ADDENDUM NO: 1

PROJECT: **SITE IMPROVEMENTS AT FRANKLIN CENTRAL JUNIOR HIGH**

CONTEXT PROJECT NO: 22-1613 DATE: 2/13/2024 BY: Fred Prazeau

PLOT DATE: 2/13/24 - 11:52 AM EDIT DATE: 2/13/24 - 11:52 AM EDITED BY: NBALENTINE DRAWING FILE Z:\PROJECTS\2023\0154 - FRANKLIN CENTRAL JR HIGH\2. DESIGN\CAD\C400 UTILITY PLAN TENNIS PAVED LOT.DWG
PLOT SCALE 1:1 PRINT DATE: 2/13/24

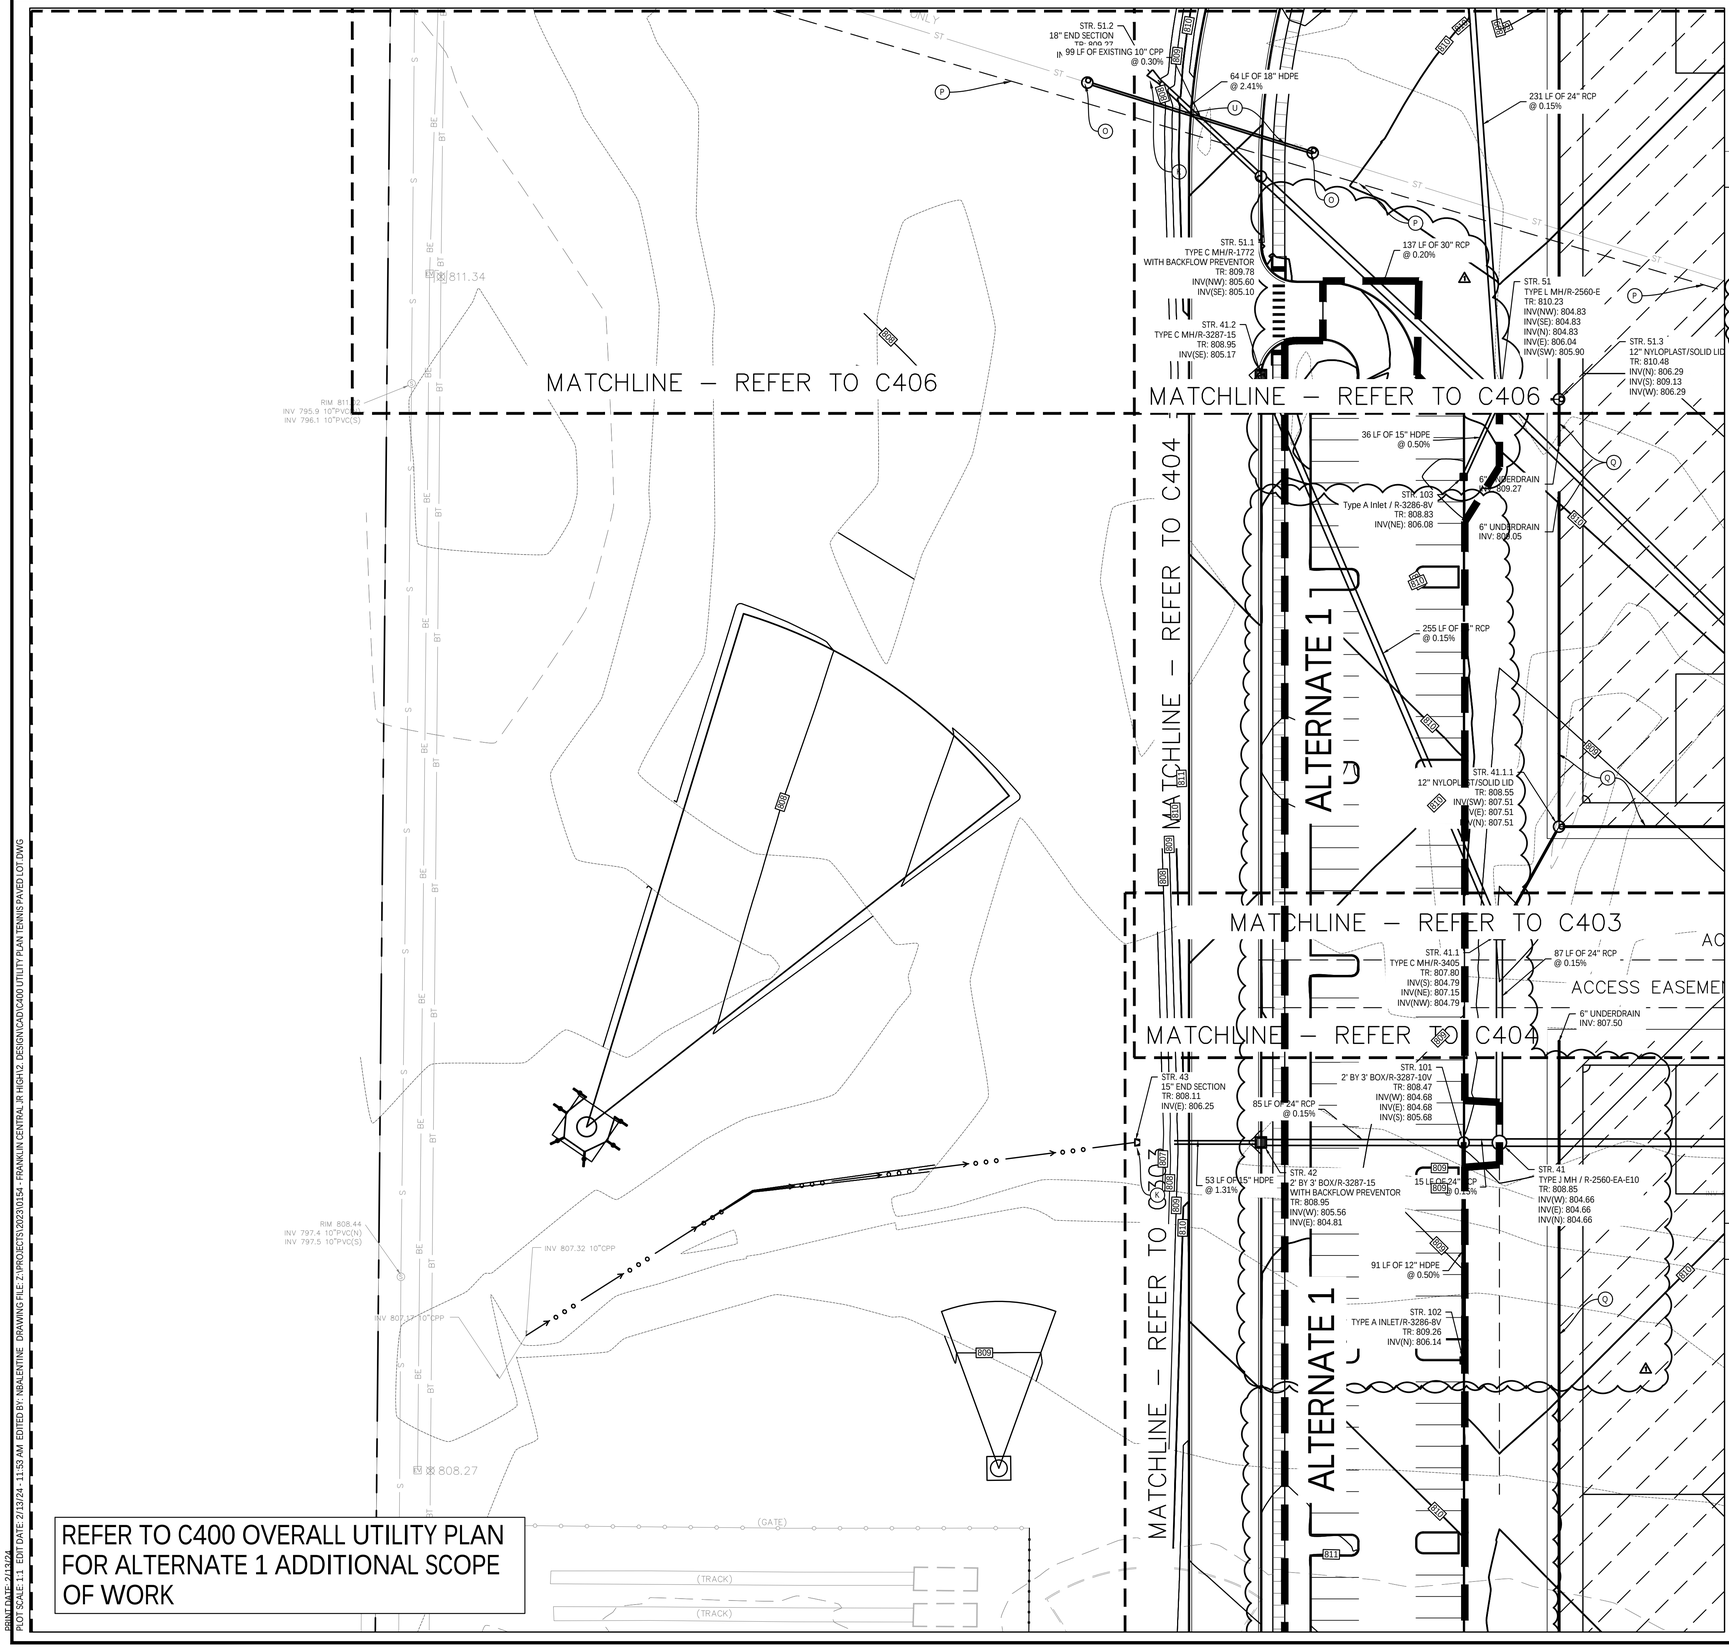
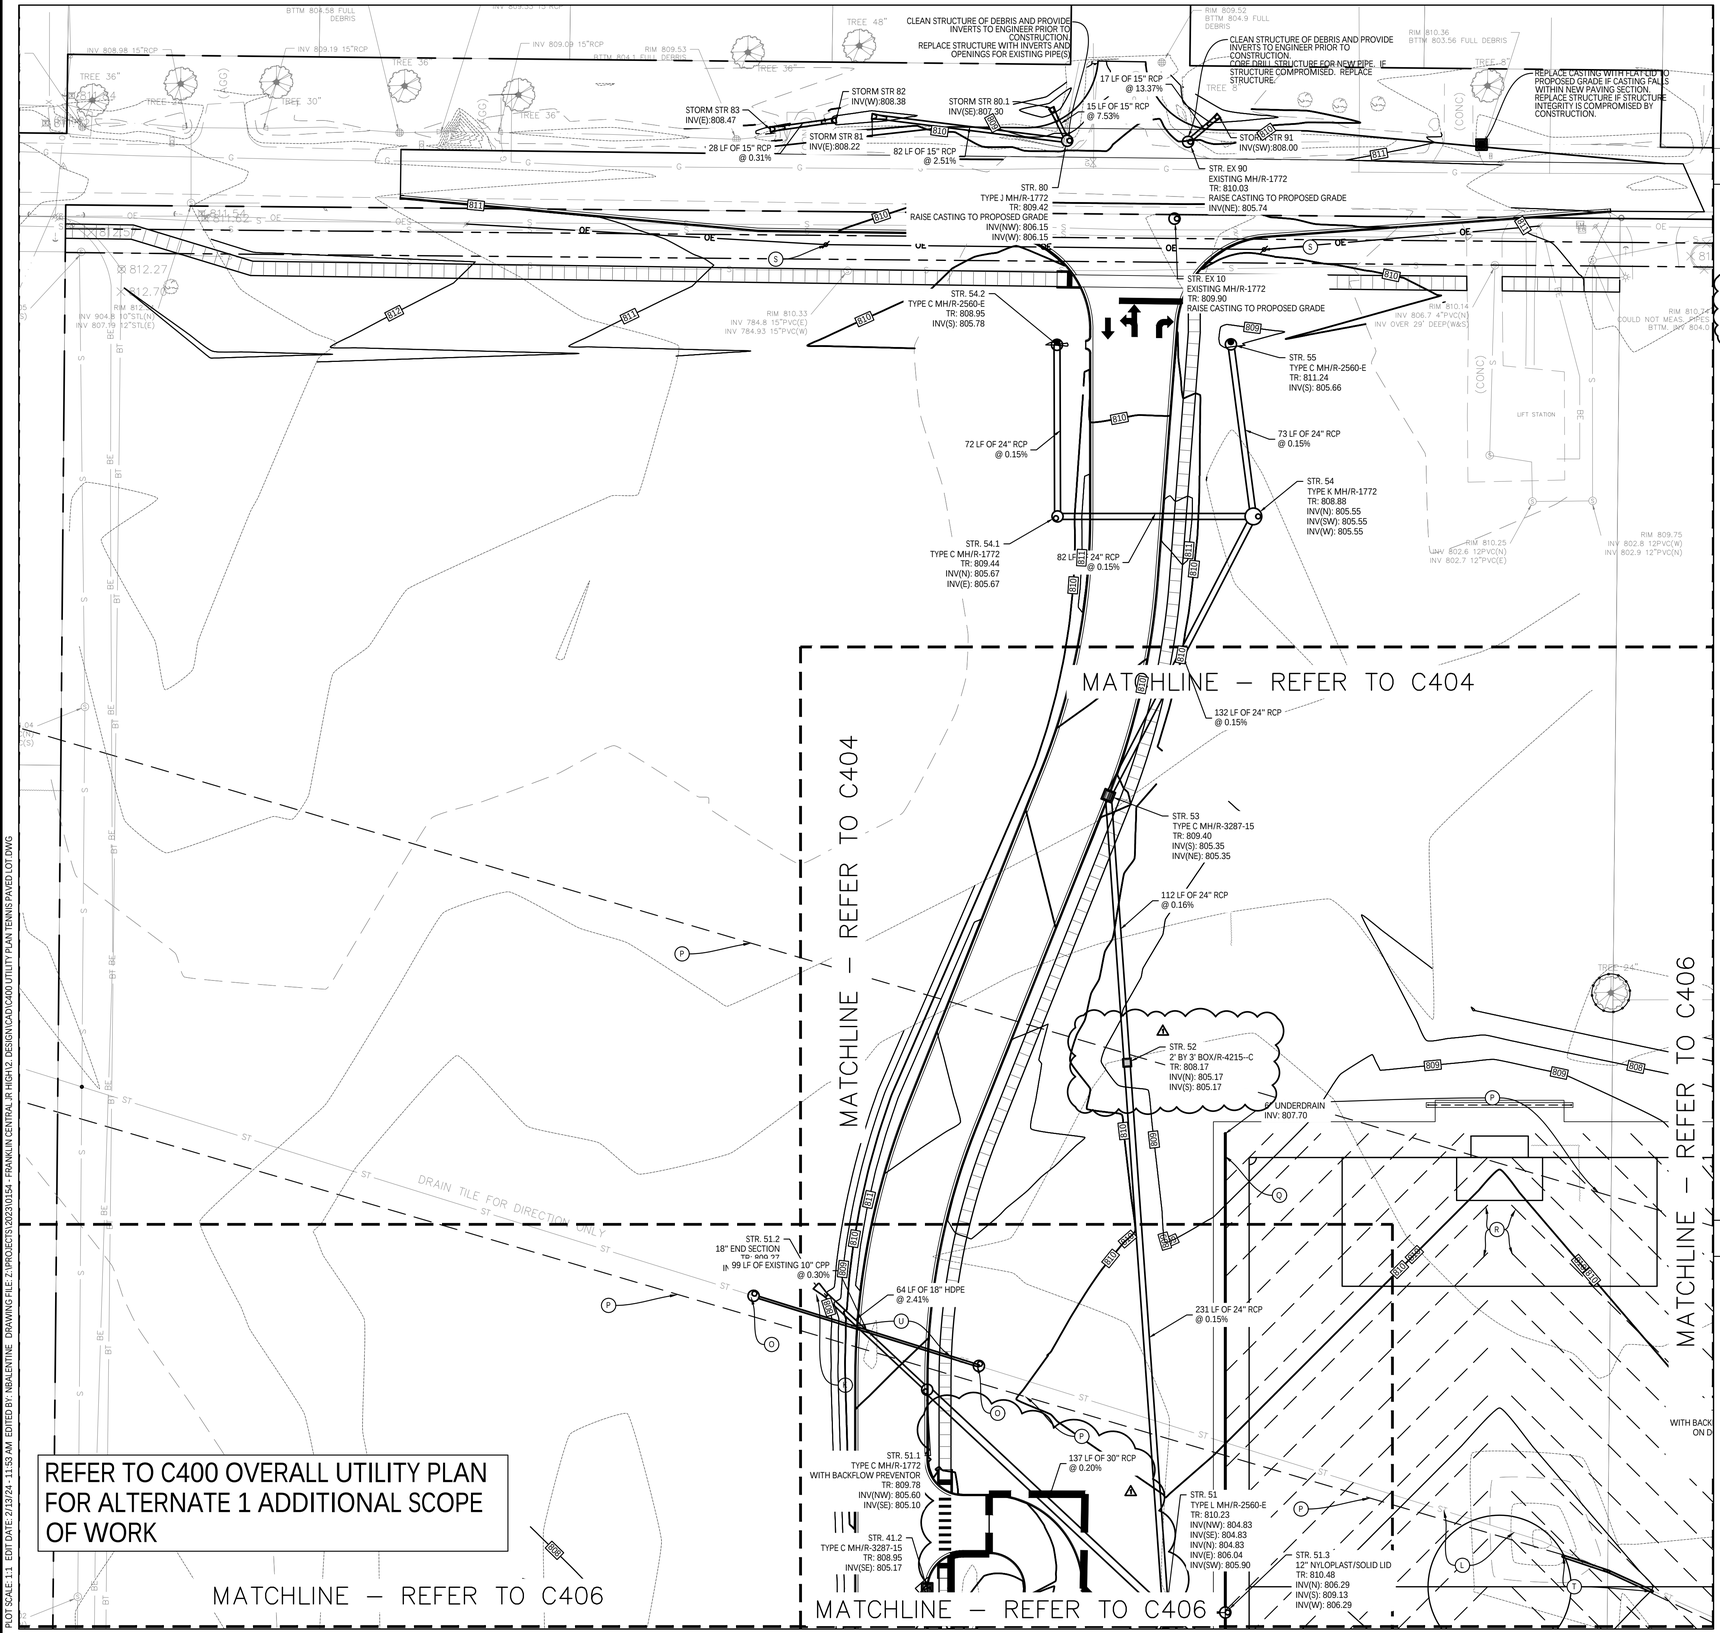
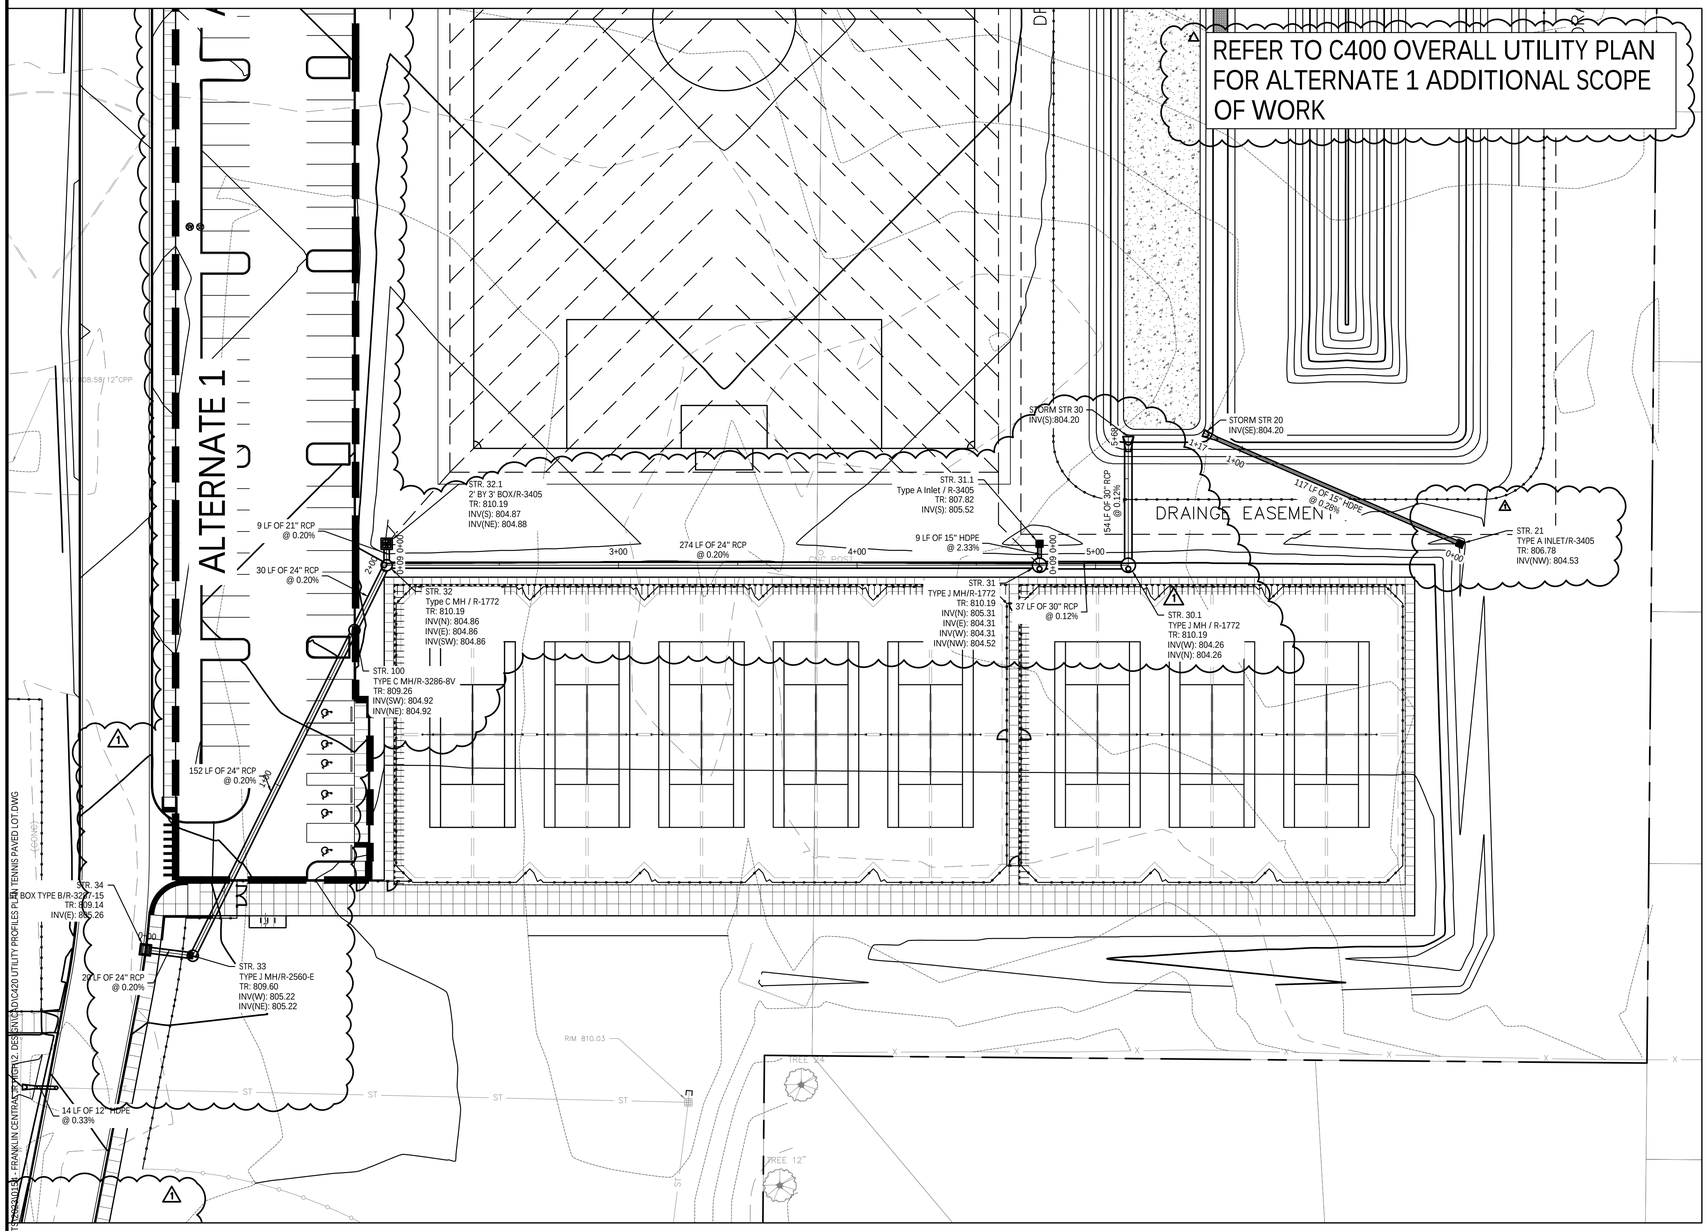
3. C400-Series Utility Plans reissued to address City comments, including clarification to storm structures to reflect grading revisions and sufficient cover, subsurface drainage as indicated on plans, storm structure network for Alternate #1 – Soccer Parking, and relocation of sprinkler vault in the vicinity of the soccer lot.
